RIVERBEND CROSSING
FILING NO. 1
STREET, STORM, & STRIPING
CONSTRUCTION DRAWINGS

RIVERBEND CROSSING FILING NO. 1 STREET IMPROVEMENT, STORM SEWER, AND SIGNAGE & STRIPING CONSTRUCTION DRAWINGS

PCD FILE #: SF1844

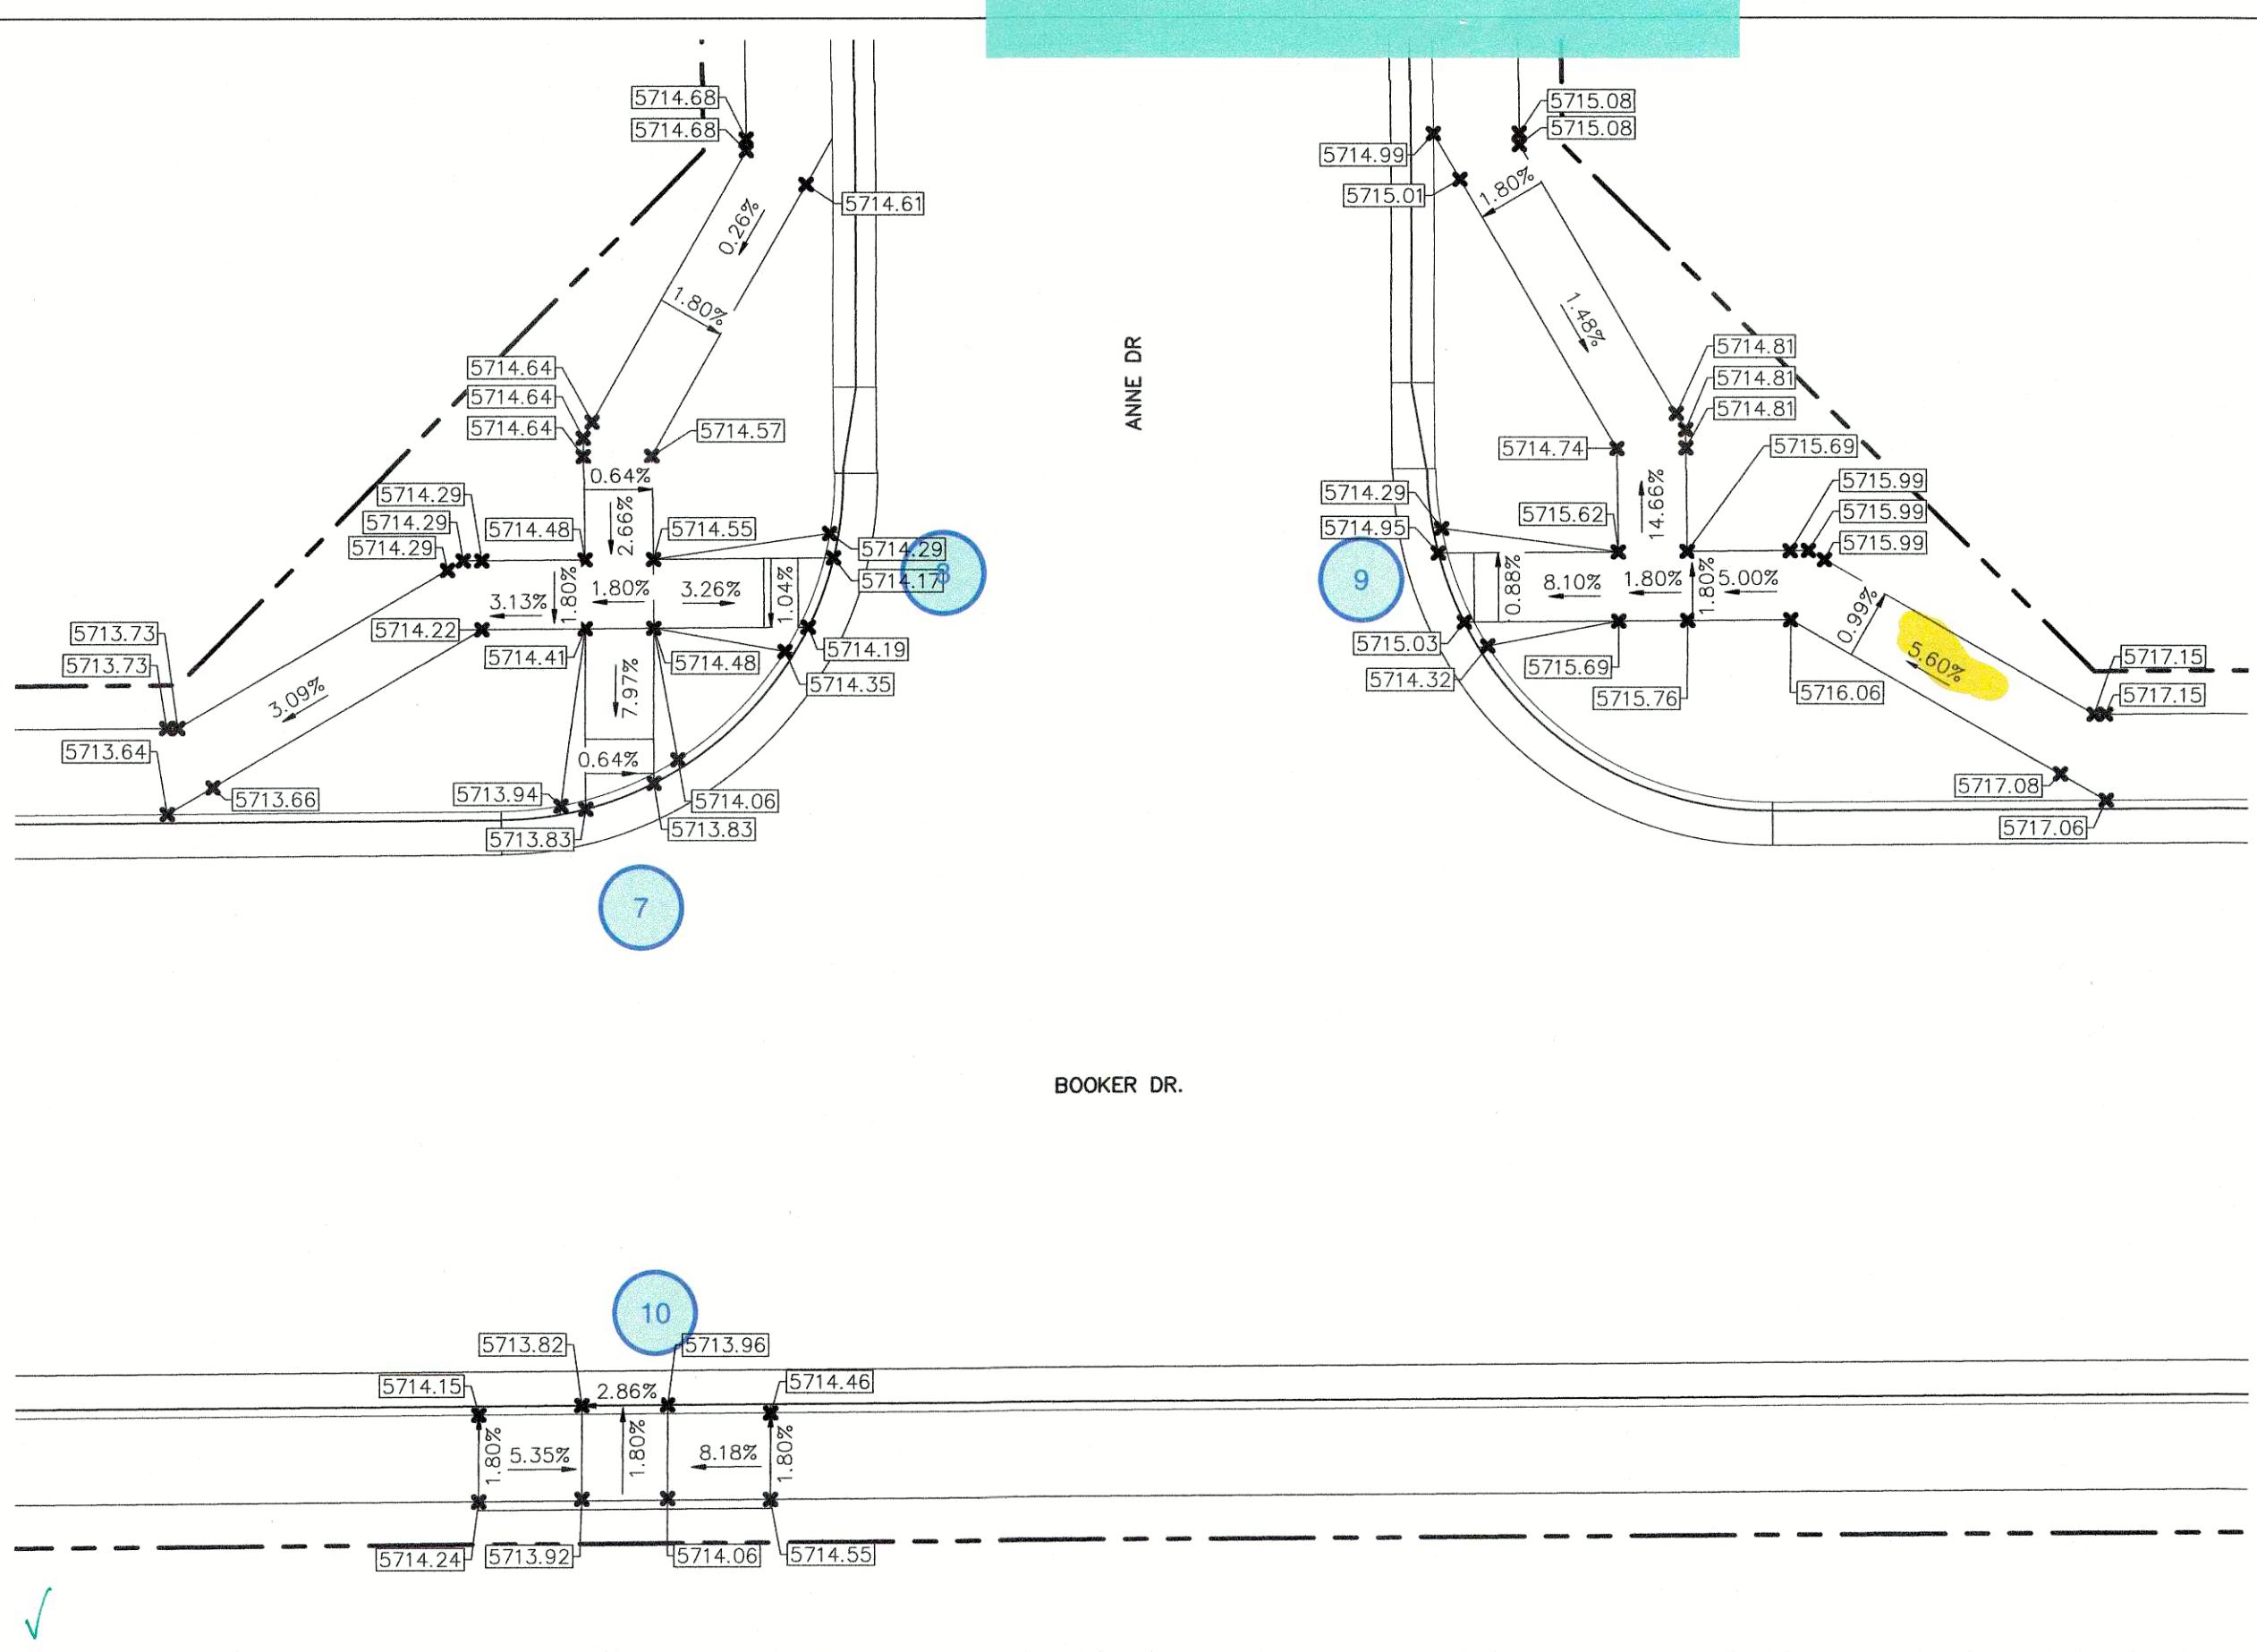
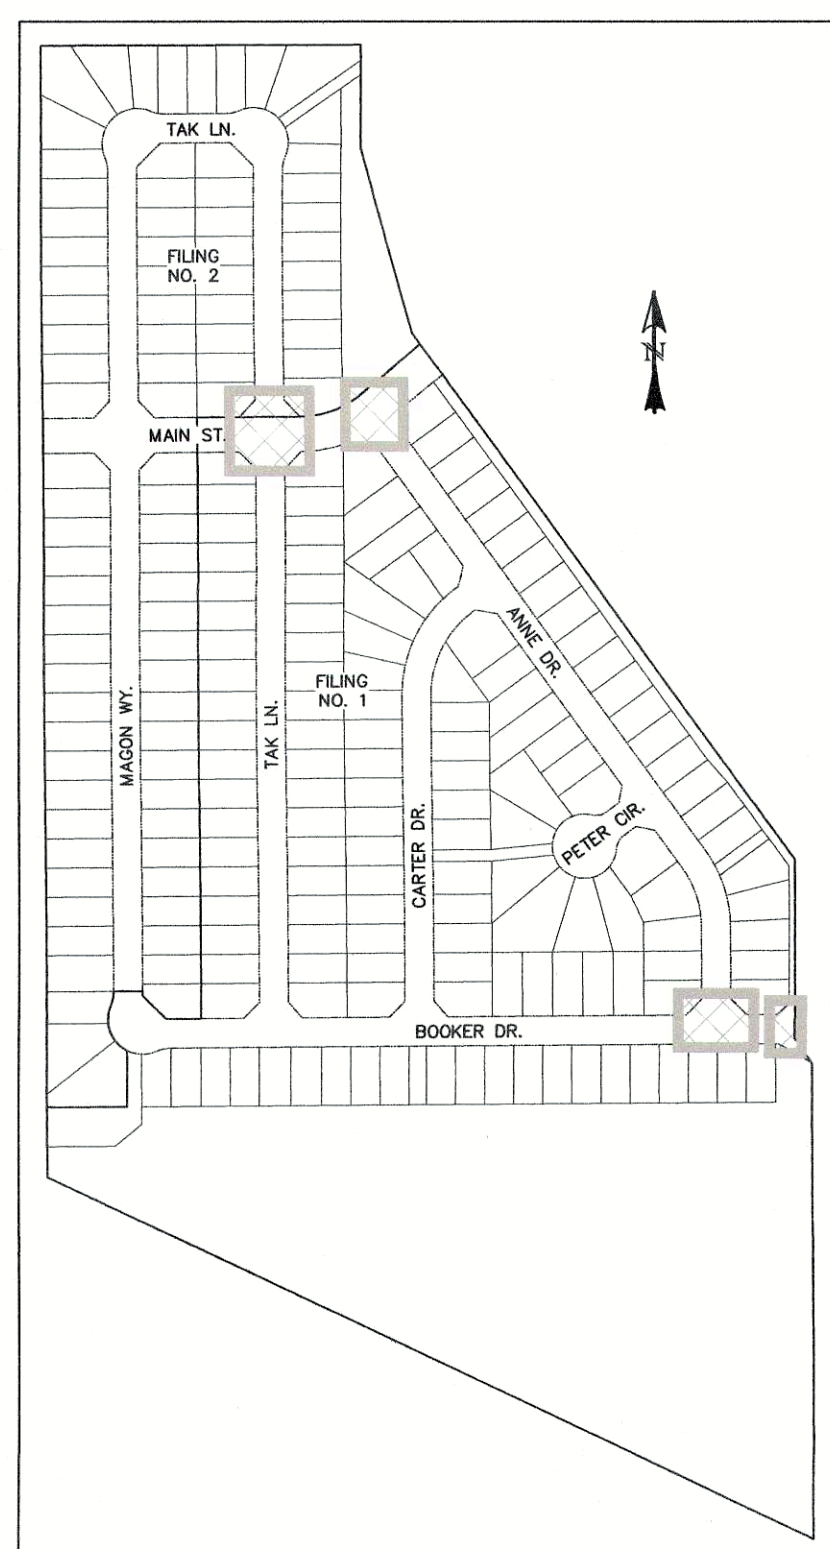
Revise. Does not meet criteria per ECM Chapter 6 Section 6.3.1.G. Slopes between 5% and 8.3% are ramp runs and must not have a change in direction. A landing pad at the top and bottom of the ramp run is required. Install a curb on both side of the ramp run per Section 6.3.1.G.6. Adjust other areas on the project with similar condition.
